Our Ref: 2998 - St Gabriels
Your Ref: 135278/FO/2022

RE: St Gabriels – Discharge of Drainage Condition 13

We have been commissioned by our client (McLaren) to discharge **Planning Condition 13** associated with the Planning Permission reference 135278/FO/2022.

TITLE
**PROPOSED BELOW GROUND DRAINAGE
SURFACE WATER LAYOUT**

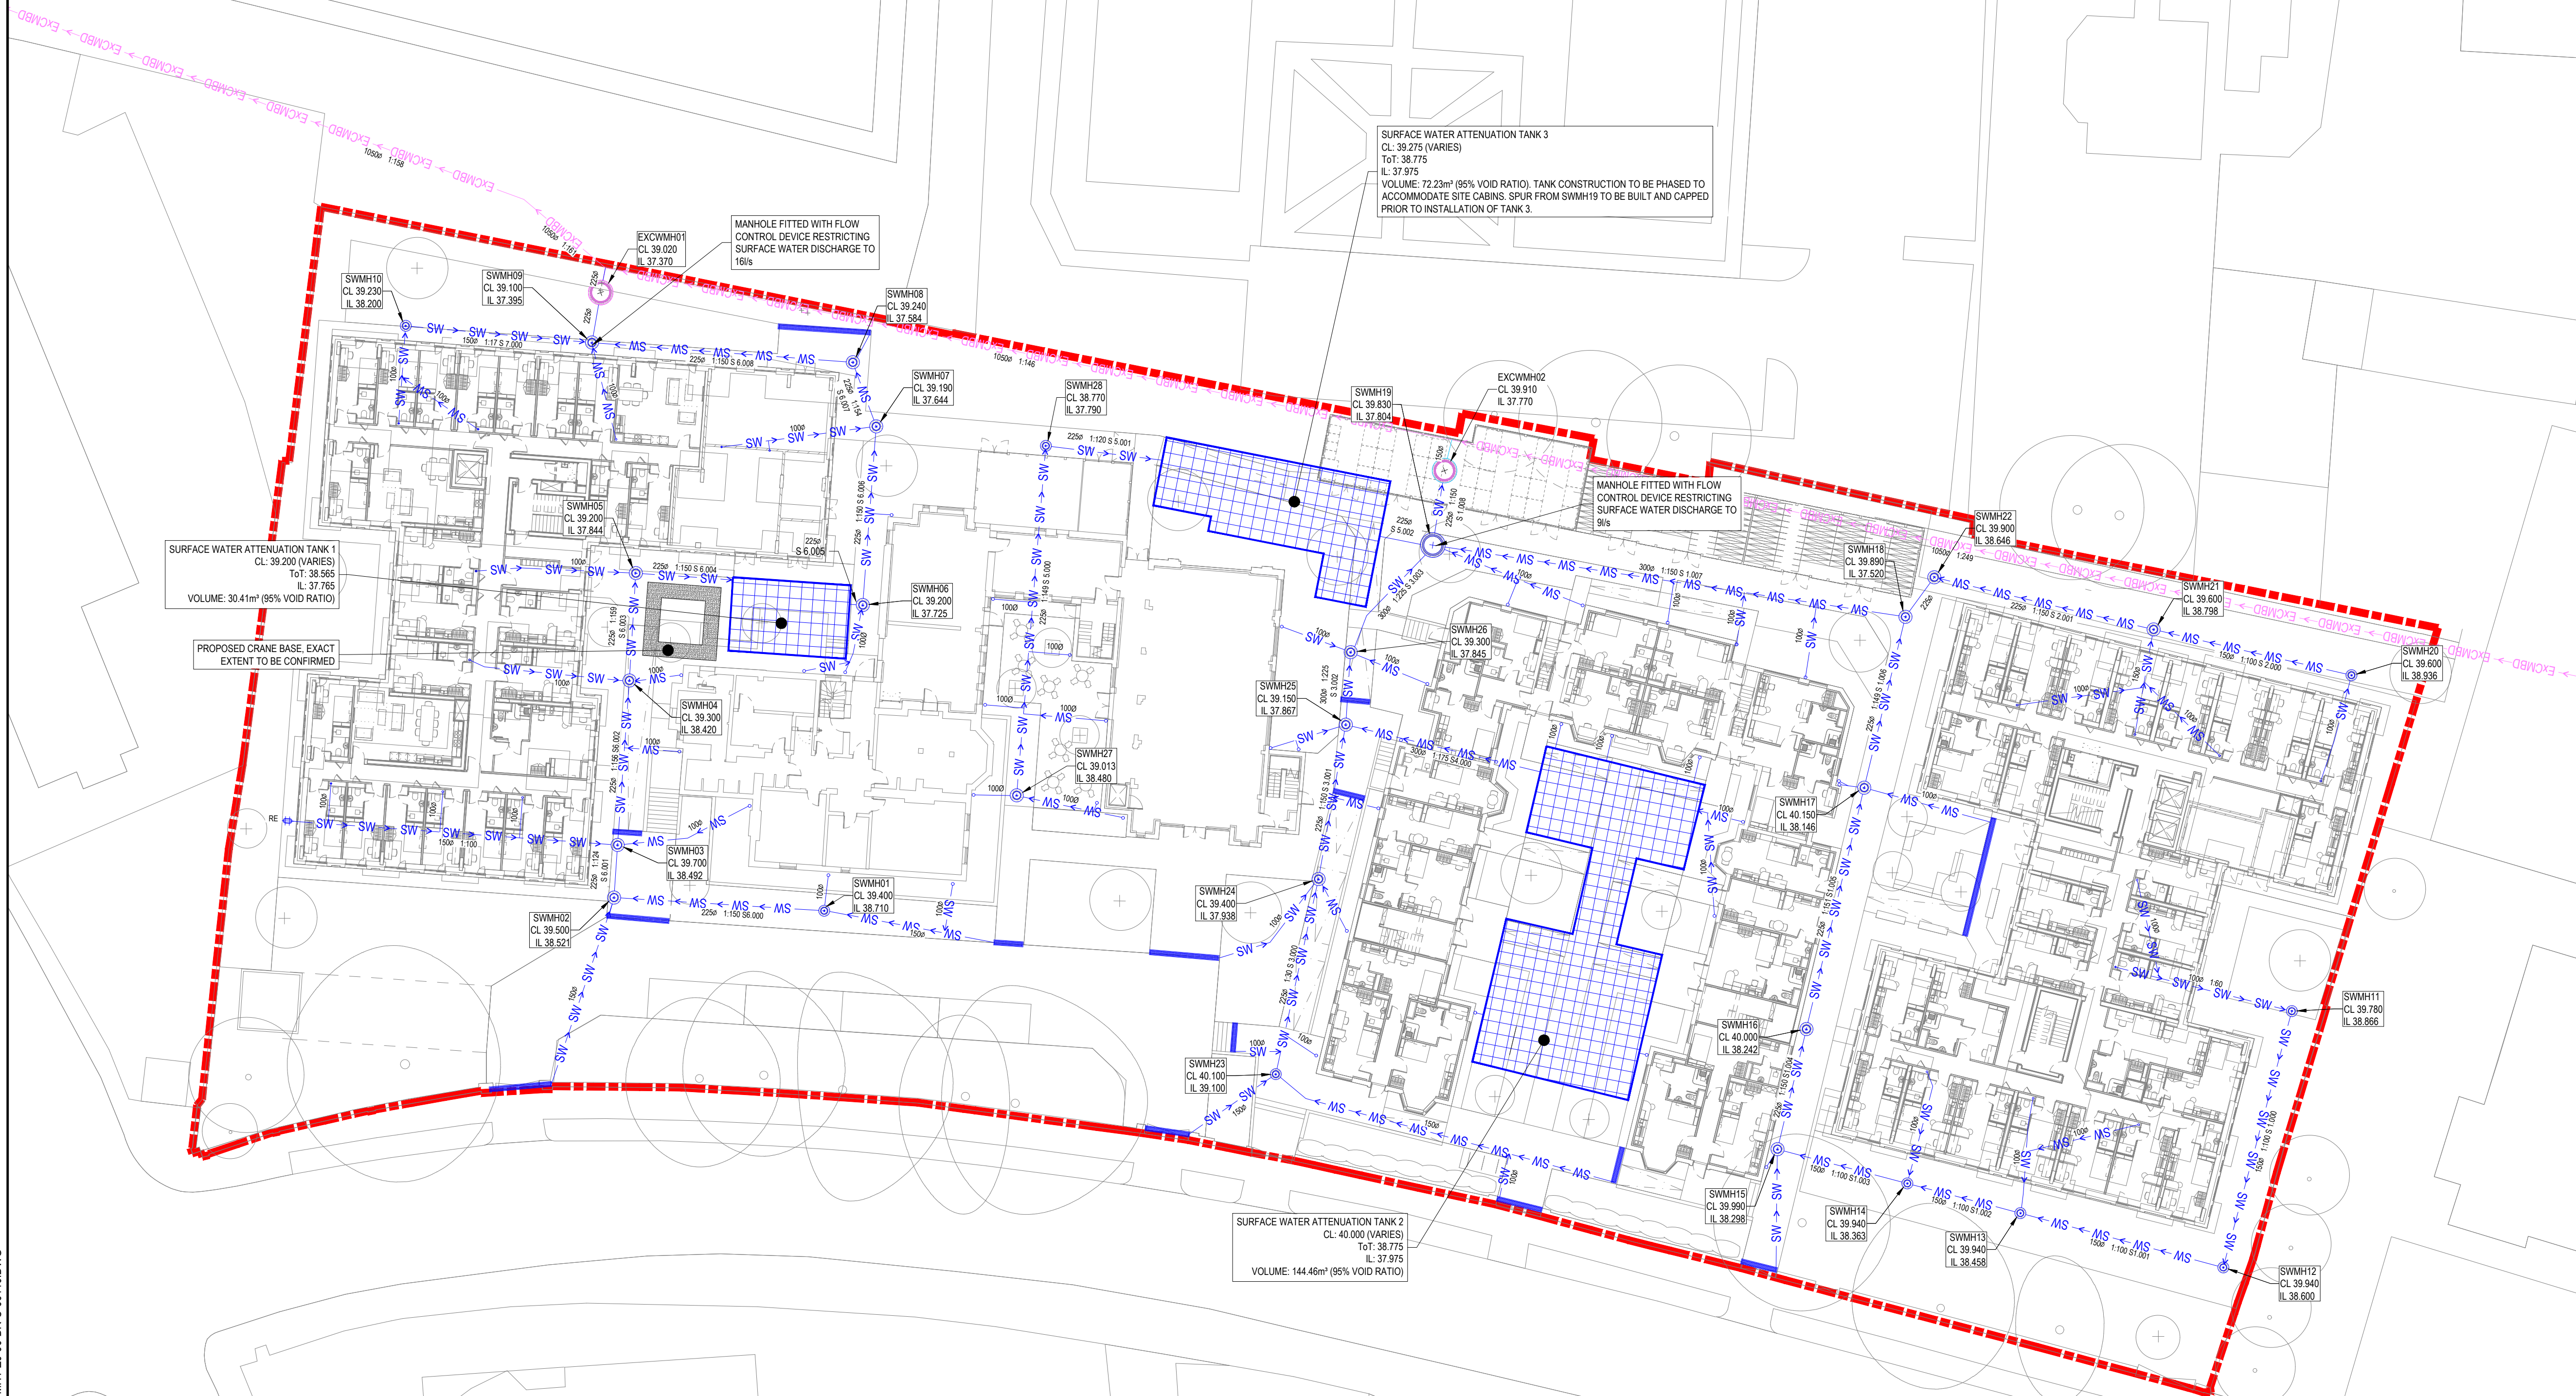
A finalised drainage layout showing all components, outfalls, levels and connectivity, including connectivity to the public sewer and compliance with easements where applicable; - To assist our reviewing process. It would be useful to the LLFA if the developer can provide an engineering drawing with cover levels, invert levels, and pipe references on one drainage drawing please.

The attenuation tank dimensions, and min cover level need to be provided on the engineering layout, per structure (attenuation tank 1, 2, and 3)

During a 1:100years + 45% cc event, the MicroDrainage indicates SWMH06 is discharging 17.5l/s. This is 1.5l/s above the approved rate.

MHT Response 1: We have updated the surface water layout as requested to show all information on the single drawing.

MHT Response 2: MD model has been updated to suit the layout, the indicated discharge rate has been rectified. Refer to **Appendix B**.

TITLE
**PROPOSED BELOW GROUND DRAINAGE
FOUL WATER LAYOUT**

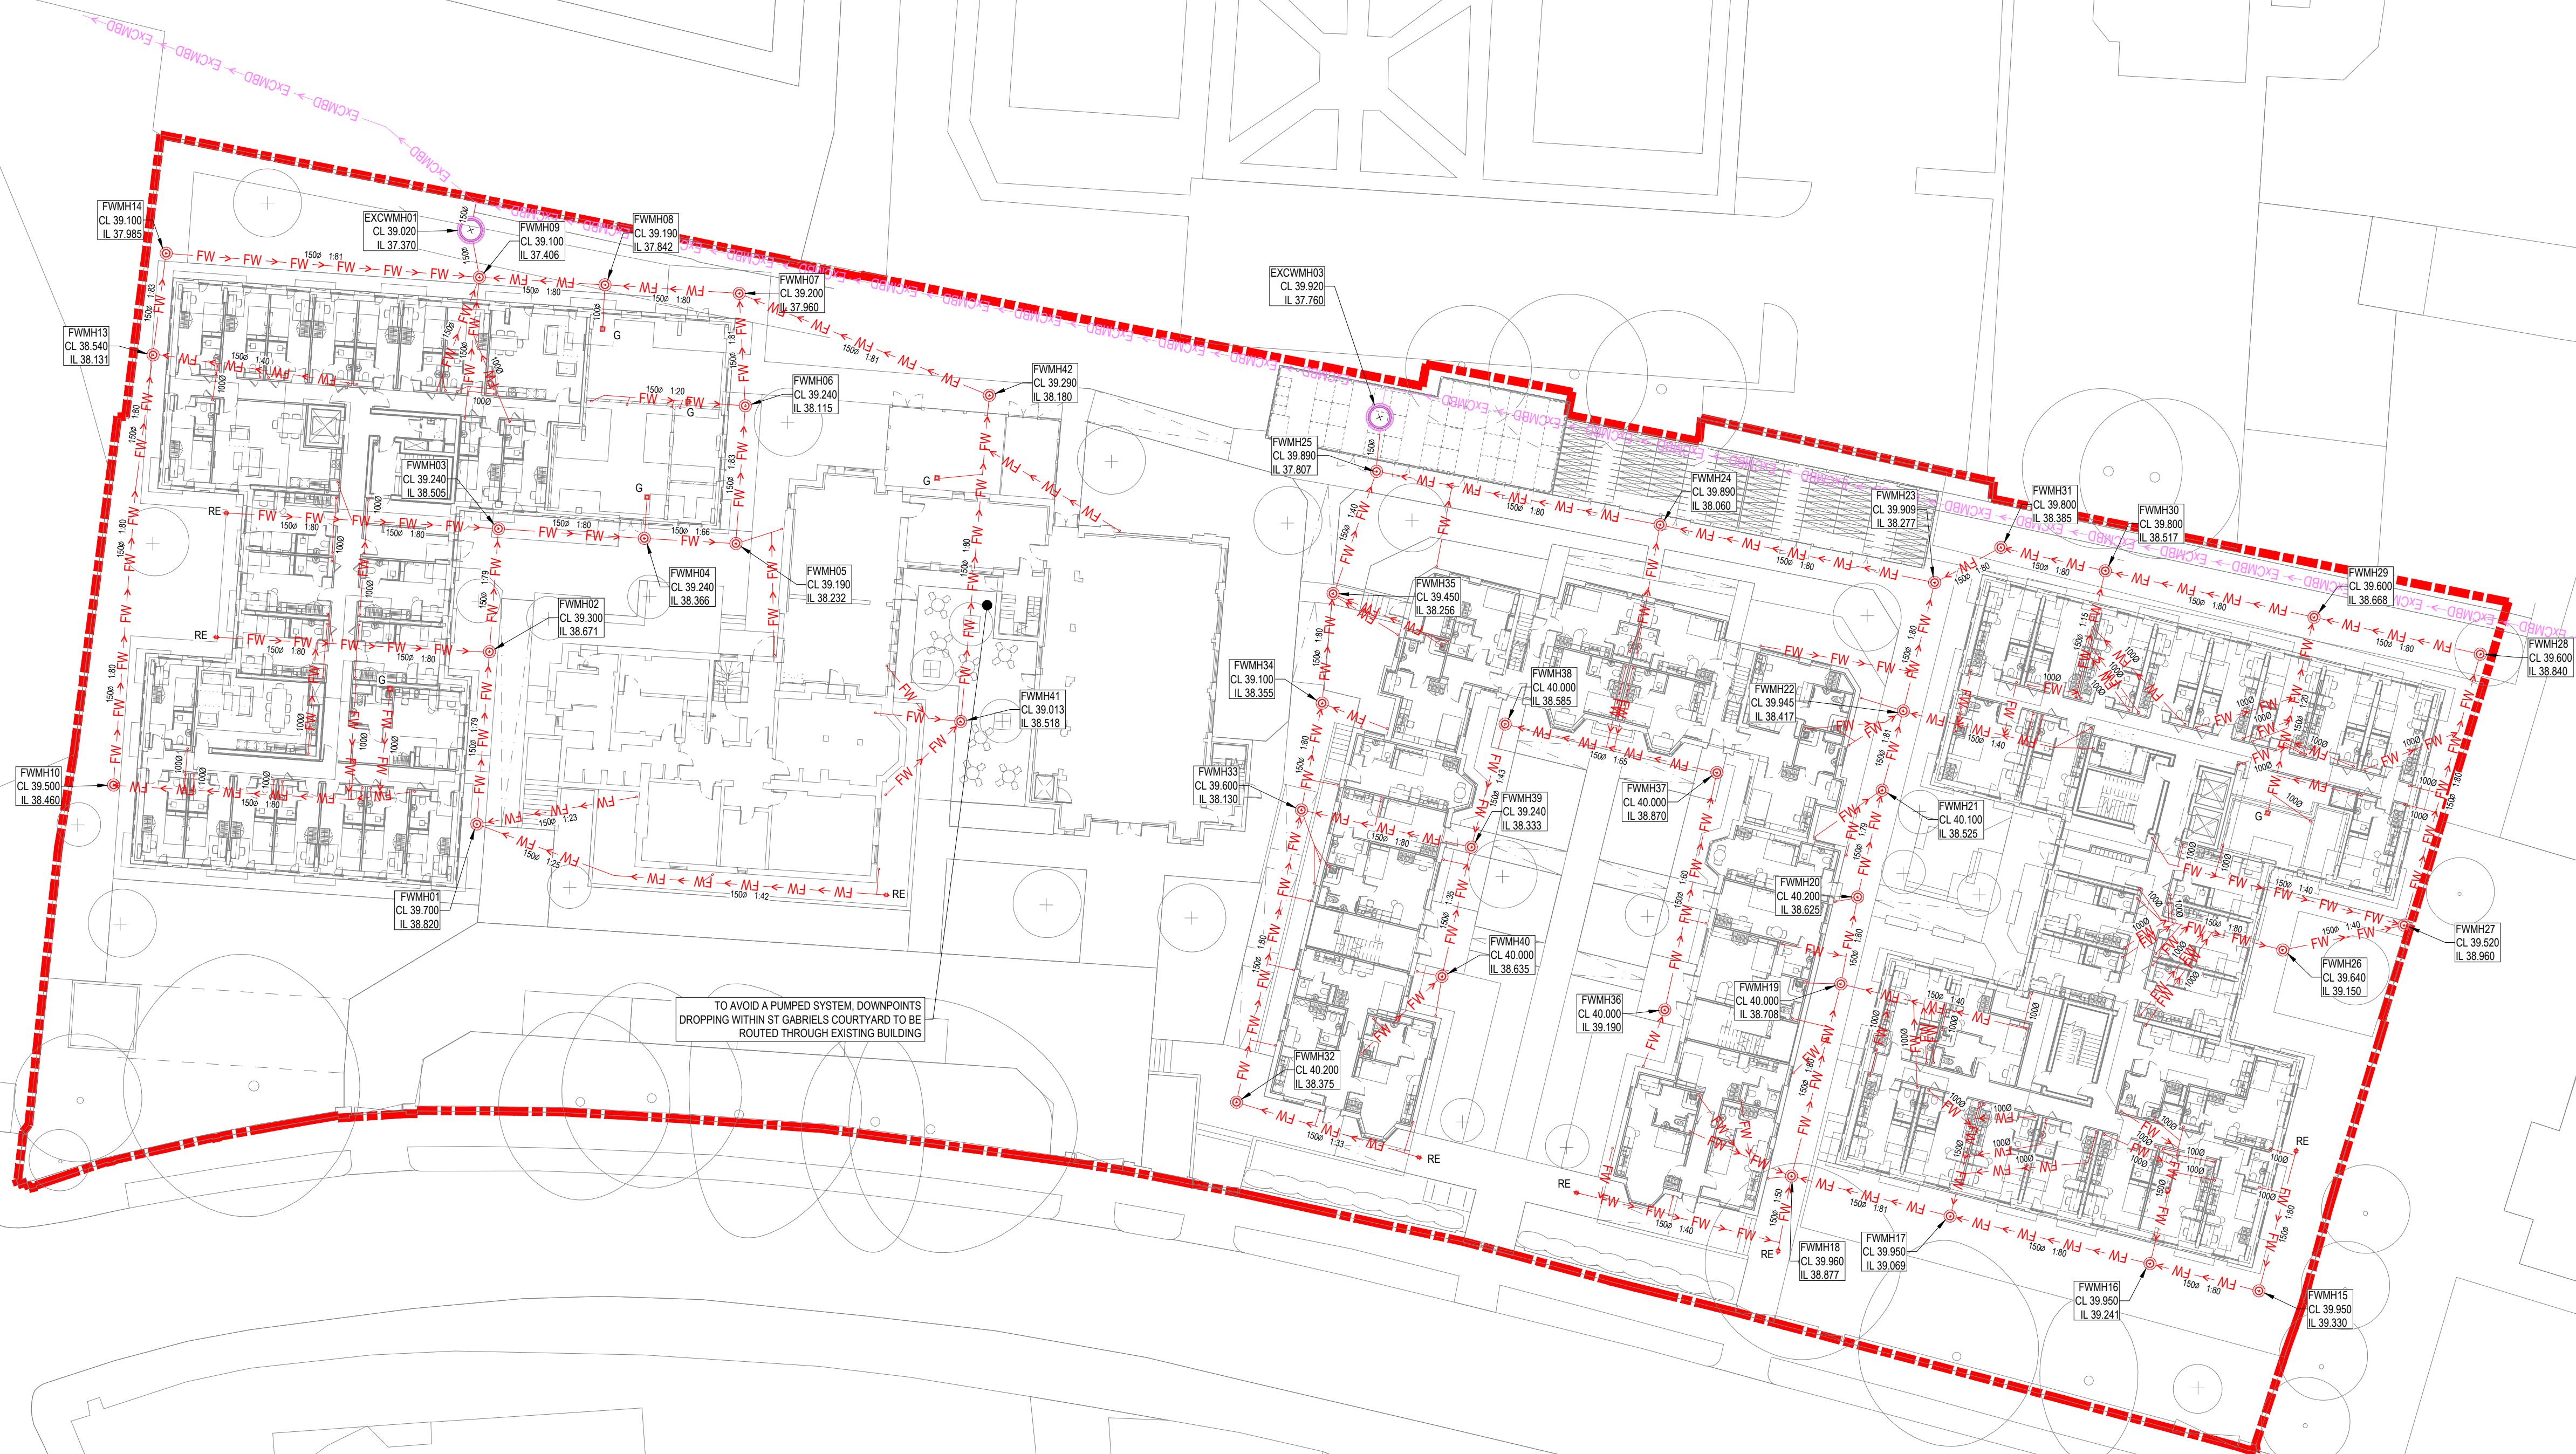
FWMH26 appears to be situated directly above attenuation tank 2, can the developer please provide a engineering section to review any potential clashes, and ensure appropriate easement.

The proposed level of cover is provided for each tank on the GA. i.e. top of tank and cover provided. There is no clash the foul water drain run.

TYPICAL ATTENUATION TANK PLAN
(Scale 1:75)

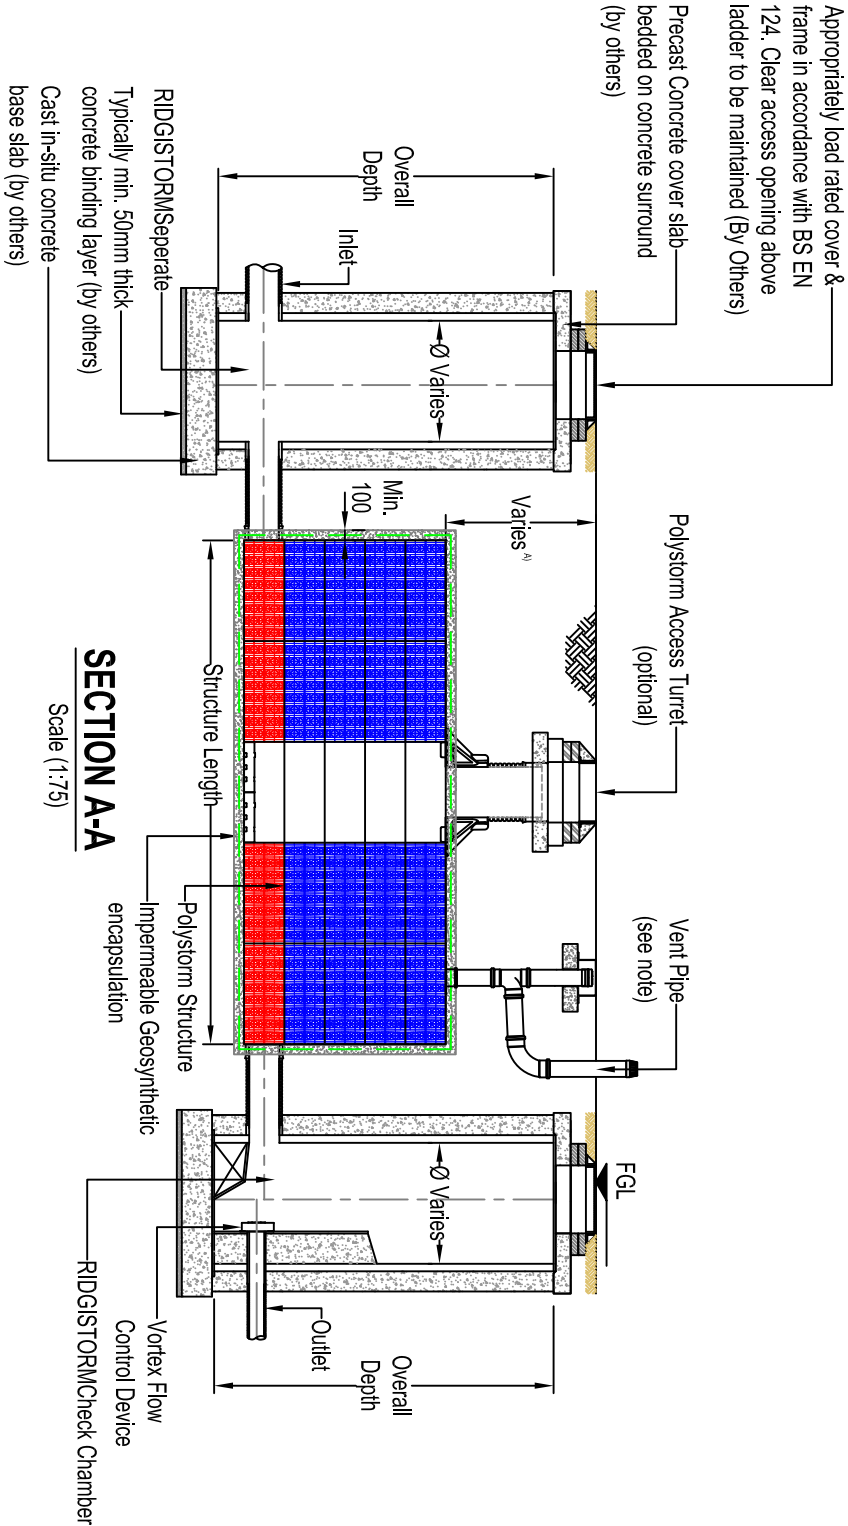
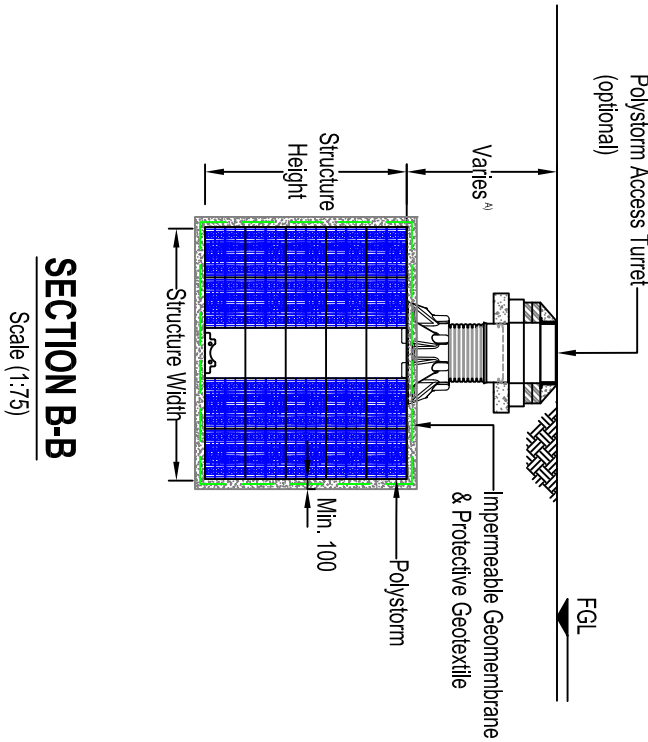
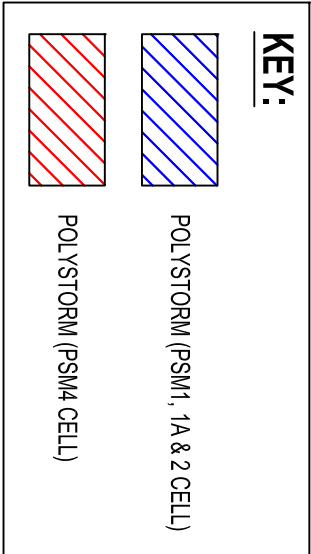
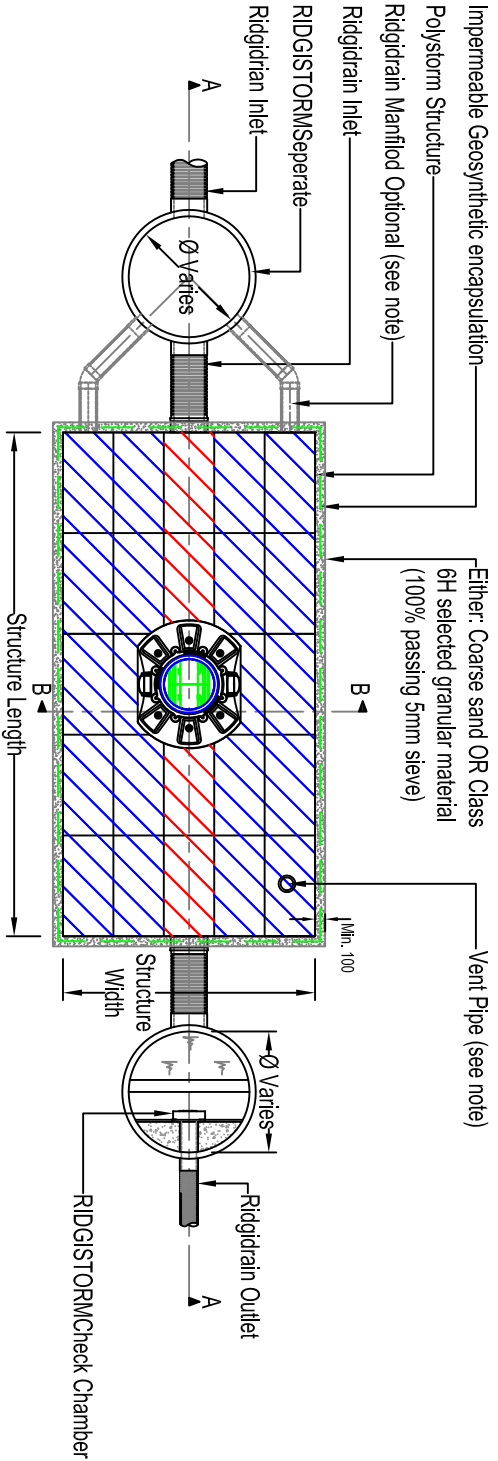
Construction details of flow control and SuDS elements. - Level of cover needs to be provided per tank.

The developer should also provide a section of foundations and tank structures per each tank to review.

Easements from proposed development footprint and boundary must be provided. SuDS features must be appropriately positioned away from proposed buildings. The developer will need to confirm the current attenuation tank easements from proposed building. Good practice is typically 2.5-meters easement from existing boundaries, 5-meters from any building, to enable future maintenance access. This must be reflected in the approved layout.

We are not at a stage where bespoke tank details can be provided in proximity to structures, the tanks have been positioned based on available space externally and as far as we can be away from building structures. We cannot provide a 2.5 or 5.0m easement around each tank as there would simply not be enough space to locate the attenuation tanks. If the tanks needed to be replaced then temporary works and propping will be required to facilitate any potential tank excavation. We note easements are preferable but we are very constrained in achieving the required attenuation volumes, with site constraints such as proposed utilities.

Any attenuation used will be design to manufacturers requirements and have a BBA certification outlining their approval to the required standards in terms of loading and creep.
